UNITED STATES PATENT AND TRADEMARK OFFICE

APPLICATION NO.	FILING DATE	FIRST NAMED INVENTOR	ATTORNEY DOCKET NO.	CONFIRMATION NO.
10/790,080	03/02/2004	Chen-Yang Huang	3106-310	1117

Office Action Summary	Application No. 10/790,080	Applicant(s) HUANG, CHEN-YANG	
	Examiner Jason M. Han	Art Unit 2875

DETAILED ACTION

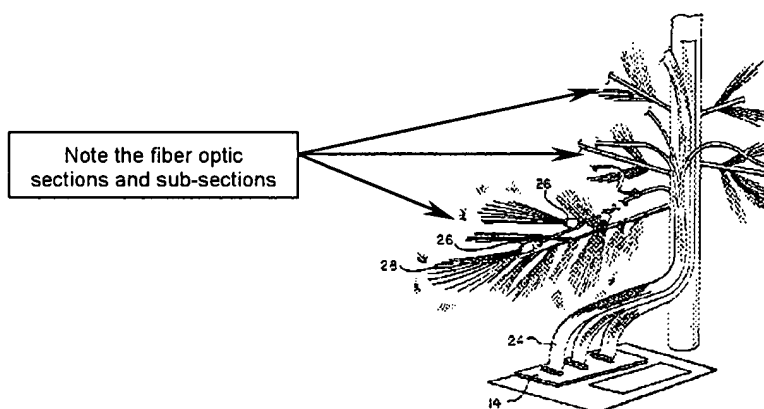
- Whereby the lighting elements are linked with power lines and control lines

[Figure 5: (24)] supplying power to fiber optic sections and sub-sections

[Figure 6: (4); Figure 4]; and

- Whereby each subsection has the lighting elements [Figure 5: (26)] connected to a plurality of optic fiber branches [Figure 4: (28)] to ensure each optic fiber branch obtains sufficient even light.
